Subject: Almond 2 Power Plant (09-AFC-02)
Supplement B - Data Adequacy Responses for Cultural Resources, DA5.3-5

SUPPLEMENT B, DATA ADEQUACY, CULTURAL RESOURCES DA5.3-5

Almond 2 Power Plant

Ceres, California
(09-AFC-02)

FIGURE DA 5.3-5A (REVISED)
AREAS SURVEYED FOR
CULTURAL RESOURCES
ALMOND 2 POWER PLANT
CERES, CALIFORNIA

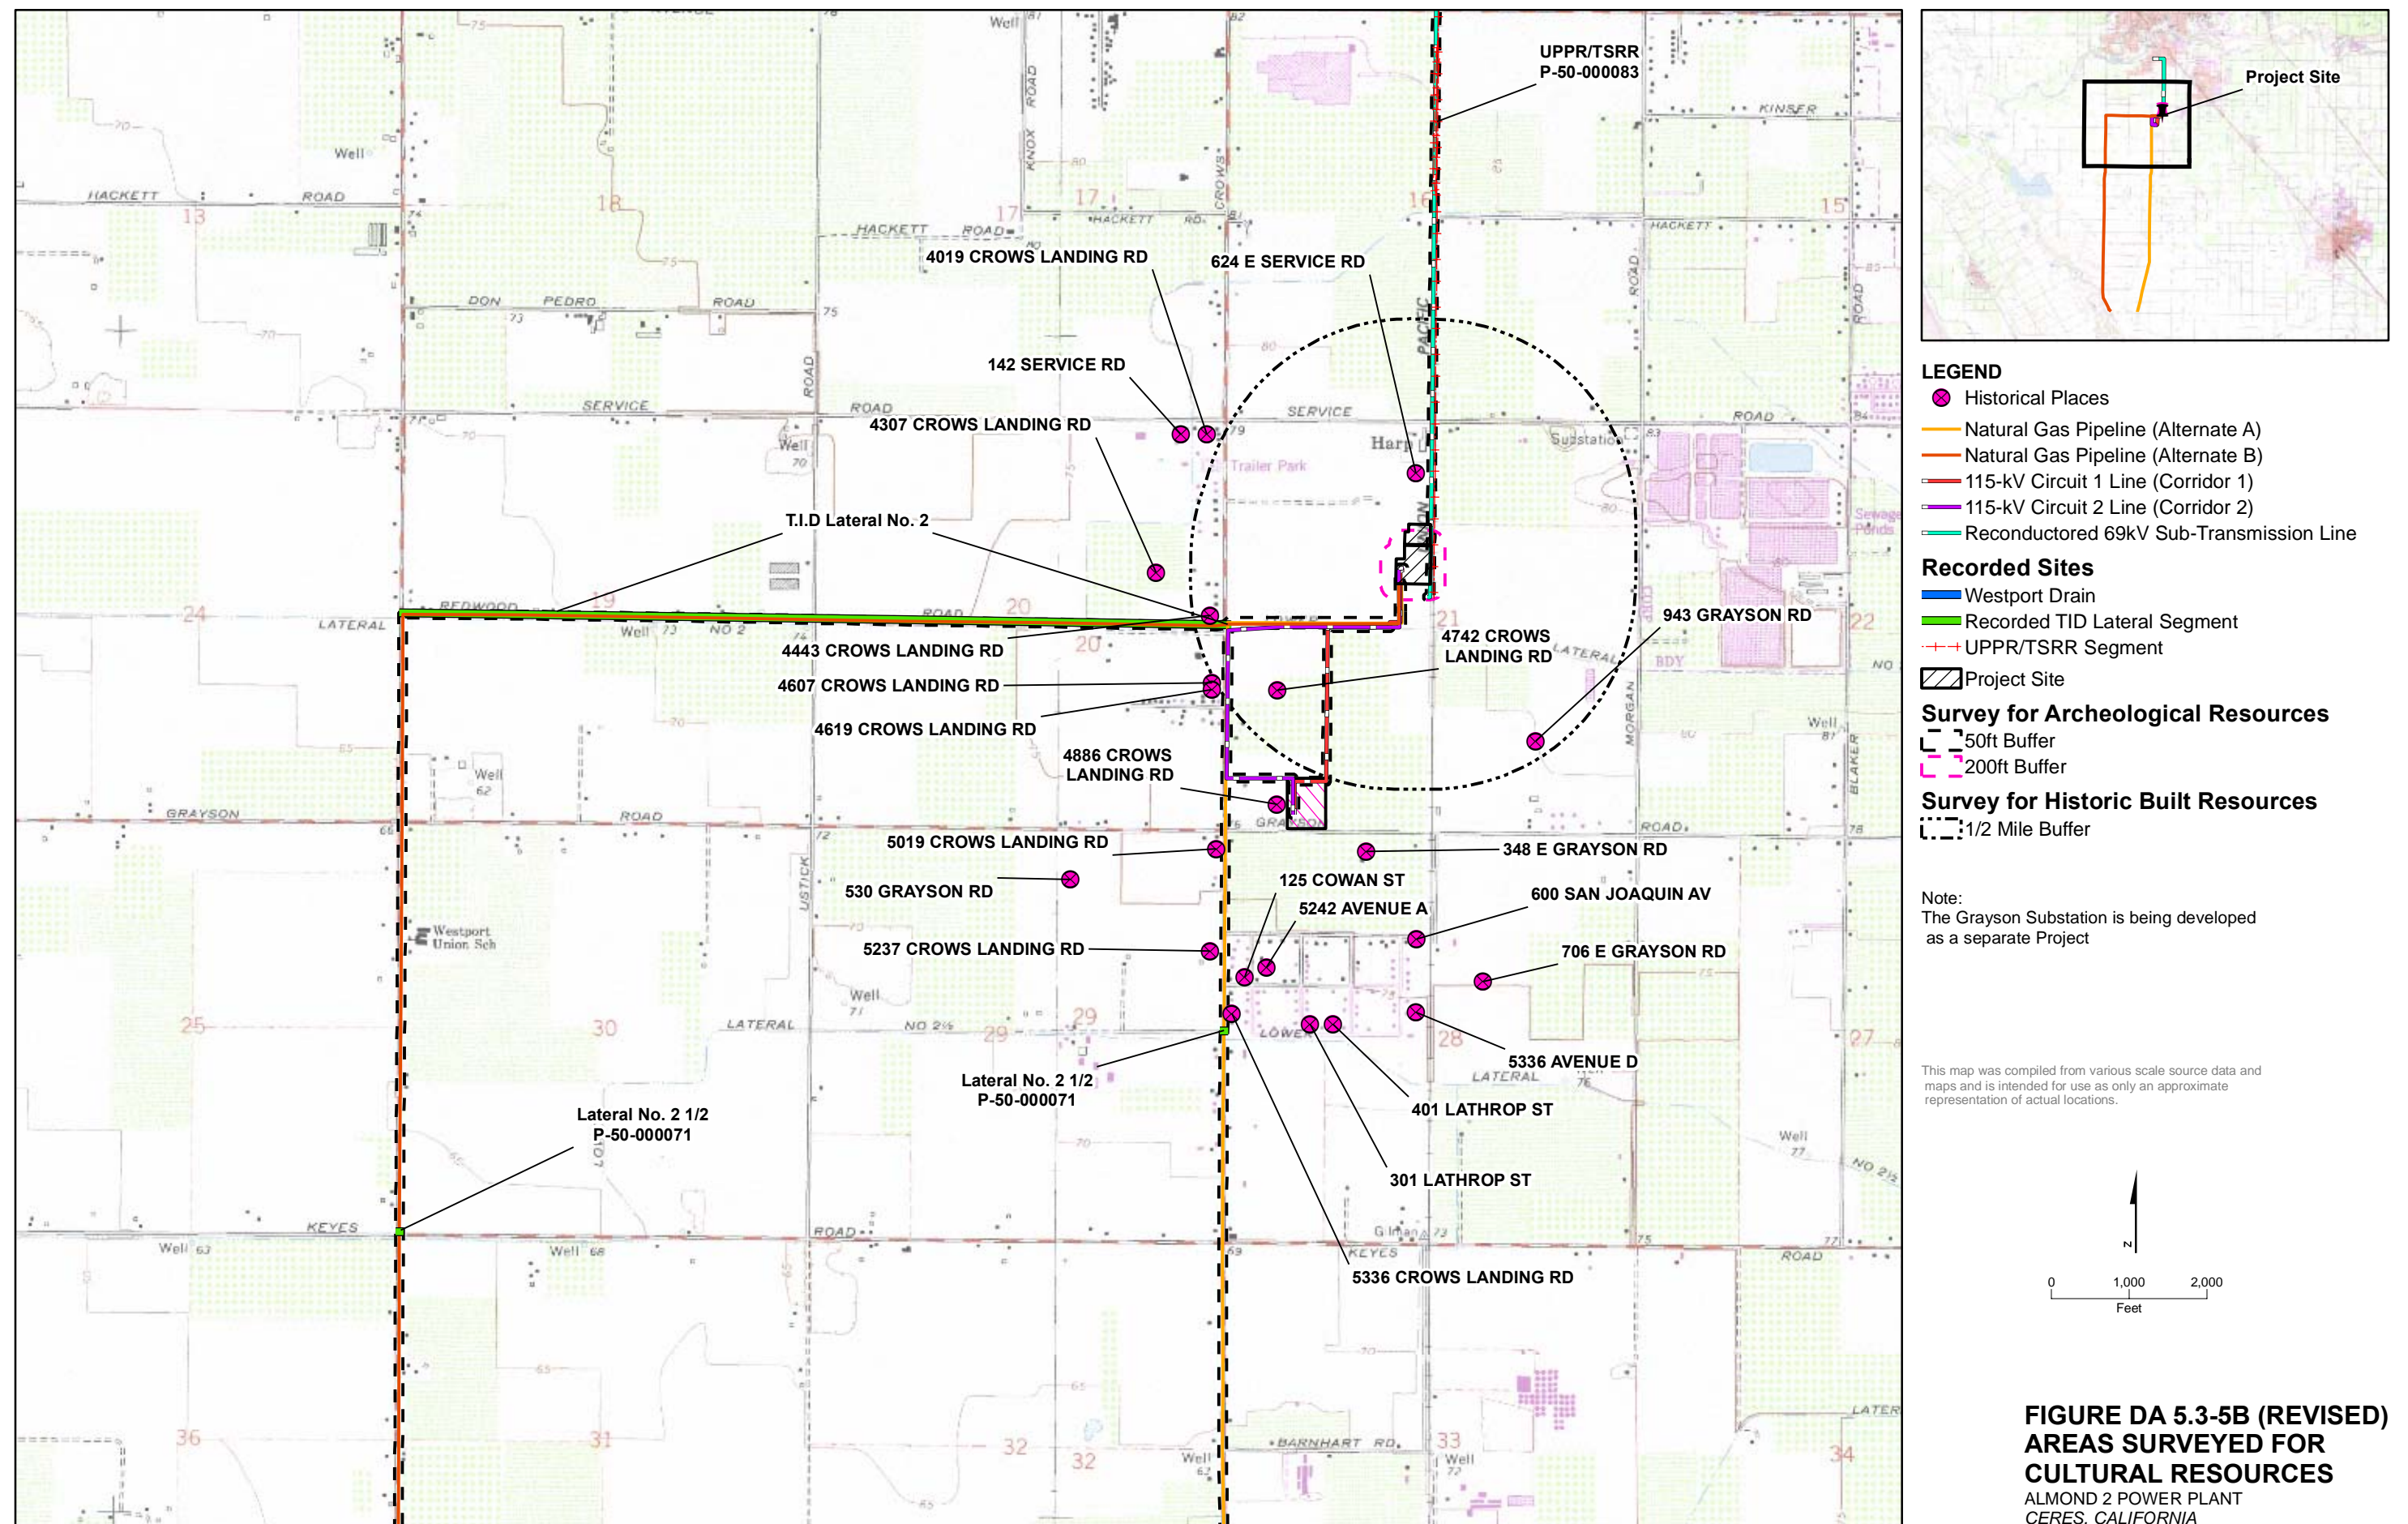
Plot locations of all previously known and newly identified cultural resources on a map or maps (at a scale of 1:24,000/U.S.G.S. topographic quadrangle) and submit under confidentiality if archaeological site locations are depicted.

Response: A map identifying previously known and newly identified cultural resources is provided as Figures DA5.3-5a through DA5.3-5d. Table DA5.3-5 identifies both previously known and newly identified cultural resources as well as record numbers (if available).
